UNITED STATES PATENT AND TRADEMARK OFFICE

APPLICATION NO.	FILING DATE	FIRST NAMED INVENTOR	ATTORNEY DOCKET NO.	CONFIRMATION NO.
10/806,870	03/23/2004	Paul B. Rivers	04-BS001 (BS030749)	2701

Office Action Summary	Application No. 10/806,870	Applicant(s) RIVERS ET AL.	
	Examiner Christine T. Cajilig	Art Unit 3637

DETAILED ACTION

Edwards (U.S. Patent No. 6,158,180).

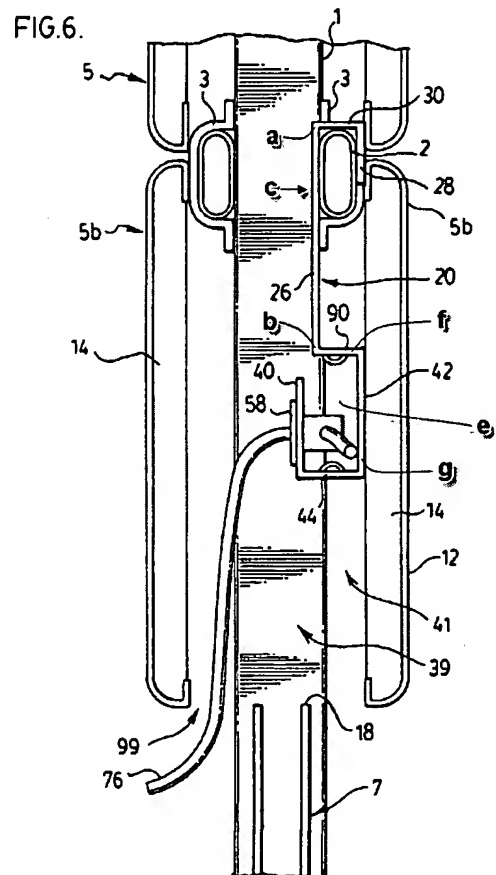
Regarding claim 1, Edwards in Figure 6 discloses a wire channel device for use with an upper siding panel and a lower siding panel, the wire channel device comprising an upwardly extending arm (26) having a top portion (a), a bottom portion (b), an inner surface (c), and an outer surface (20), the outer surface (20) of the top portion (a) having a wedgeable projection (30, 28) to engage and to secure the wire channel device between an upper siding panel and a lower siding panel; a transverse leg (90) extending outwardly from the outer surface of the bottom portion of the arm towards a downwardly extending leg (42) of a wire channel; the wire channel having the downwardly extending leg (42), a channel portion (44), and a rear upwardly extending

leg (40), wherein the downwardly extending leg (42) is longer than the rear upwardly extending leg (40) and wherein an interior (3) of the channel portion (44) defines a channel to retain a wire. The phrase "to engage and to secure the wire channel device between an upper siding panel and a lower siding panel" is regarded to as functional language and while features of an apparatus may be recited either structurally or functionally, claims directed to an apparatus must be distinguished from the prior art in terms of structure rather than function. See MPEP §2114. Furthermore, the projection (30, 28) could perform the function stated above.

Regarding claim 2, Edwards in Figure 6 discloses a wire channel wherein the channel portion comprises a substantially "U"-shaped channel (44).

Regarding claim 12, Edwards in Figure 6 discloses a wire channel wherein the projection comprises at least one substantially hook-shaped lip (30, 28).

Regarding claim 13, Edwards in Figure 6 discloses a wire channel wherein the hook-shaped lip (30, 28) has an interior angle relative to the outer surface of the top portion of at least fifteen degrees.

Regarding claim 15, Edwards in Figure 6 discloses a wire channel comprising at least one upwardly extending arm (26) having a wedgeable projection (30, 28) capable of engaging and securing the wire channel device between the upper siding panel and the lower siding panel; a transverse leg (90) extending outwardly from the arm towards a downwardly extending leg (42) of a wire channel, wherein the transverse leg is

capable of extending beneath a rearwardly facing hook portion of the upper siding panel; the wire channel having the downwardly extending leg (42), a channel portion (44), and a rear upwardly extending leg (40), wherein the downwardly extending leg (42) is longer than the rear upwardly extending leg (40) and wherein the channel portion (44) defines a channel (e) to retain a wire. As noted above, for purpose of examination the claims are considered as directed to the wire channel device; therefore, the phrases, "for use with an upper siding panel and a lower siding panel, the upper siding panel having a rearwardly-facing hook portion and a lip portion and the lower siding panel having a hooked portion complementary to the lip portion of the upper siding panel," "to engage and to secure the wire channel device between the upper siding panel and the lower siding panel," and "wherein the transverse leg extends beneath a rearwardly-facing hook portion of an upper siding panel" shall be considered as functional language or intended use. And while features of an apparatus may be recited either structurally or functionally, claims directed to an apparatus must be distinguished from the prior art in terms of structure rather than function. Examiner refers Applicant to MPEP §2114.

Regarding claim 16, Edwards in Figure 6 discloses a wire channel comprising the at least one upwardly extending arm (26) having a top portion (a), a bottom portion (b), an inner surface (c), and an outer surface (20), the outer surface (20) of the top portion (a) having the wedgeable projection (30, 28) capable of engaging and securing the wire channel device between the lip portion of the upper siding panel and the complimentary hooked portion of the lower siding panel, and a portion of the outer surface (20) of the

bottom portion (b) connected with the transverse leg (90). The phrase "to engage and to secure the wire channel device between the lip portion of the upper siding panel and a complimentary hooked portion of a lower siding panel" is regarded to as functional language and while features of an apparatus may be recited either structurally or functionally, claims directed to an apparatus must be distinguished from the prior art in terms of structure rather than function. See MPEP §2114. Furthermore, the projection (30, 28) could perform the function stated above.

Reinke (U.S. Patent No. 1,772,687)

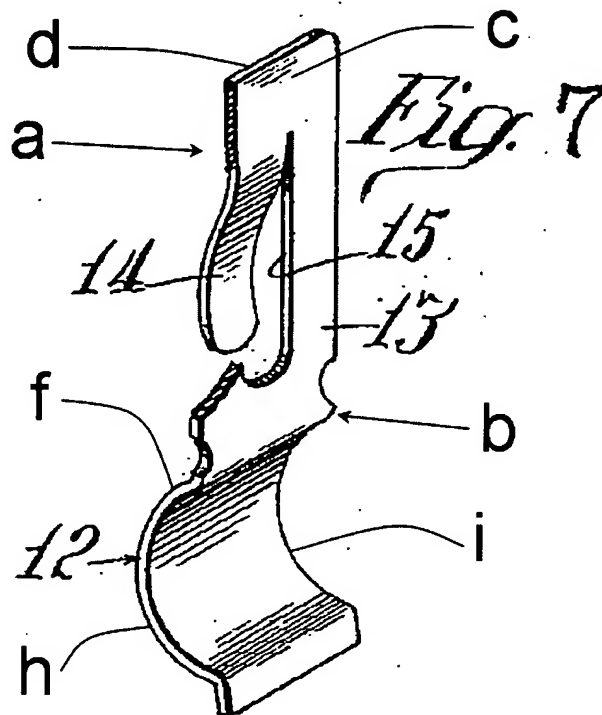
Regarding claim 1, Reinke in Figure 7 discloses a wire channel device for use with an upper siding panel and a lower siding panel, the wire channel device comprising: an upwardly extending arm (13) having a top portion (a), a bottom portion (b), an inner surface (c), and an outer surface (d), the outer surface (d) of the top portion (a) having a wedgeable projection (14) to engage and to secure the wire channel device between an upper siding panel and a lower siding panel; a transverse leg (f) extending outwardly from the outer surface of the bottom portion of the arm towards a downwardly extending leg (12) of a wire channel; the wire channel having the downwardly extending leg (12), but does not disclose a channel portion and a rear upwardly extending leg, wherein the downwardly extending leg is longer than the rear upwardly extending leg and wherein an interior of the channel portion defines a channel to retain a wire. However, Sugiyama disclose a securing device with a channel (a) and a rear upwardly extending leg (2') wherein an interior of the channel portion defines a channel to retain

tubular members (P). Therefore, it would have been obvious to a person having ordinary skill in the arts at the time of the Applicant's invention to modify Reinke to have a channel portion with a rear upwardly extending leg as taught by Sugiyama to provide a clamping means to better secure wires that will be held within the channel. The phrase "to engage and to secure the wire channel device between an upper siding panel and a lower siding panel" is regarded to as functional language and while features of an apparatus may be recited either structurally or functionally, claims directed to an apparatus must be distinguished from the prior art in terms of structure rather than function. See MPEP §2114. Furthermore, the projection (30, 28) could perform the function stated above.

Regarding claim 12, Reinke already modified by Sugiyama discloses a wire channel as discussed above and further discloses that the wedgeable projection comprises at least one substantially hook-shaped lip (14).

Regarding claim 15, Reinke discloses a wire channel comprising at least one upwardly extending arm (2) having a wedgeable projection (14) capable of engaging and securing the wire channel device between the upper siding panel and the lower siding panel; a transverse leg (f) extending outwardly from the arm towards a downwardly extending leg (12) of a wire channel, wherein the transverse leg is capable of extending beneath a rearwardly facing hook portion of the upper siding panel; the wire channel having the downwardly extending leg (12), but does not disclose a channel portion, and a rear upwardly extending leg, wherein the downwardly extending leg is longer than the rear upwardly extending leg and wherein the channel portion defines a channel to retain a wire. However, Sugiyama disclose a securing device with a channel (a) and a rear upwardly extending leg (2') wherein an interior of the channel portion defines a channel to retain tubular members (P). Therefore, it would have been obvious to a person having ordinary skill in the arts at the time of the Applicant's invention to modify Reinke to have a channel portion with a rear upwardly extending leg as taught by Sugiyama to provide a clamping means to better secure wires that will be held within the channel. As noted above, for purpose of examination the claims are considered as directed to the wire channel device; therefore, the phrases, "for use with an upper siding panel and a lower siding panel, the upper siding panel having a rearwardly-facing hook portion and a lip portion and the lower siding panel having a hooked portion

FIG. 29

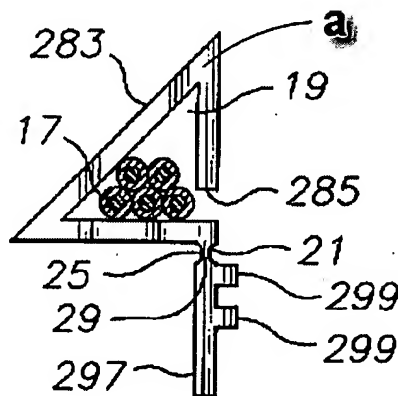
Regarding claim 10, Reinke already modified by Sugiyama discloses a wire channel as discussed above but does not disclose the downwardly extending leg extending downward at an angle of at least thirty degrees toward the transverse leg. However, Zimmerman in Figure 29 discloses a flanged conduit having the downwardly extending leg (283) extending downward at an angle of at least thirty degrees toward the arm (297). Therefore, it would have been obvious to a person having ordinary skill in the arts at the time of the applicant's invention to modify the wire channel of Reinke

Regarding claim 4, Edwards discloses a wire channel as discussed above but does not disclose a channel portion comprising a substantially "V"-shaped channel. However, Zimmerman in Figure 29 discloses a flanged conduit having a channel portion (a) comprising a substantially "V"-shaped channel (19). Therefore, it would have been

Regarding claim 10, Edwards discloses a wire channel as discussed above but does not disclose the downwardly extending leg extending downward at an angle of at least thirty degrees toward the transverse leg. However, Zimmerman in Figure 29 discloses a flanged conduit having the downwardly extending leg (283) extending downward at an angle of at least thirty degrees toward the arm (297). Therefore, it would have been obvious to a person having ordinary skill in the arts at the time of the applicant's invention to modify the wire channel of Edwards to include the downwardly extending leg extending downward at an angle of at least thirty degrees toward the transverse leg to provide a channel with a variety of configurations (Col 2, Ln 19-21).

Brooks (U.S. Patent No. 5,823,655)

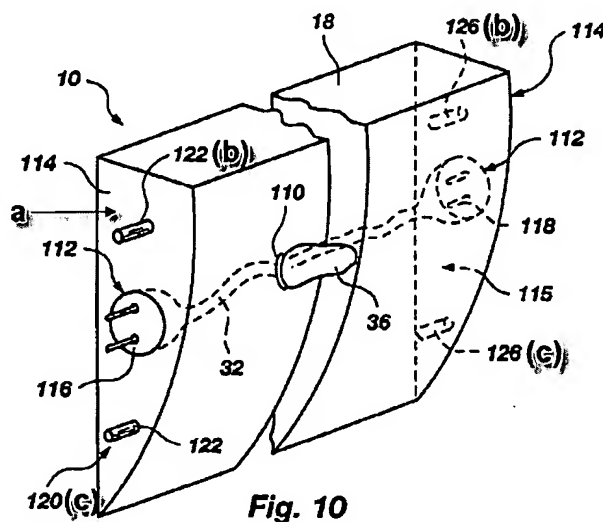
Regarding claims 5 and 17, Edwards discloses a wire channel as discussed above and also including transverse leg (90) comprising a first lateral side (f) and a second lateral side (opposite side of (f)) but does not disclose the first lateral side having a female repository and the second lateral side having a male projection, wherein the male projection of a first wire channel device mates with the female repository of a second wire channel device such that the first wire channel snap fits into alignment and secures with the second wire channel. However, Brooks in Figure 10 discloses channeled molding having a transverse leg (114) further comprising a first lateral side (115) and a second lateral side (a), the first lateral side having a female repository (126 (b)) and the second lateral side having a male projection (122 (b)), wherein the male projection of a first wire channel device mates with the female repository of a second wire channel device such that the first wire channel snap fits into alignment and secures with the second wire channel (Col 7, Ln 54-56). Therefore, it would have been obvious to a person having ordinary skill in the arts at the time of the applicant's invention to modify the wire channel of Edwards to include the first lateral side having a female repository and the second lateral side having a male projection, wherein the male projection of a first wire channel device mates with the female repository of a second wire channel device such that the first wire channel snap fits into

Regarding claims 6 and 18, Edwards discloses a wire channel as discussed above and also disclose that the channel portion further comprises a first lateral side (g) and a second lateral side (opposite side of (g)) but does not disclose the first lateral side having a female repository and the second lateral side having a male projection, wherein the male projection of a first wire channel device mates with the female repository of a second wire channel device to align and secure the first wire channel device with the second wire channel device. However, Brooks in Figure 10 discloses channeled molding having a first lateral side (115) and a second lateral side (a), the first lateral side having a female repository (126 (c)) and the second lateral side having a male projection (122 (c)), wherein the male projection of a first wire channel device mates with the female repository of a second wire channel device such that the first wire channel snap fits into alignment and secures with the second wire channel (Col 7, Ln 54-56). Therefore, it would have been obvious to a person having ordinary skill in the arts at the time of the applicant's invention to modify the wire channel of Edwards to have the channel portion further comprise a first lateral side having a female repository and the second lateral side having a male projection, wherein the male projection of a first wire channel device mates with the female repository of a second wire channel device such that the first wire channel snap fits into alignment and secures with the second wire channel as taught by Brooks to provide a means for extending the length of the channel. Furthermore, it has been held that the mere rearrangement of parts, such
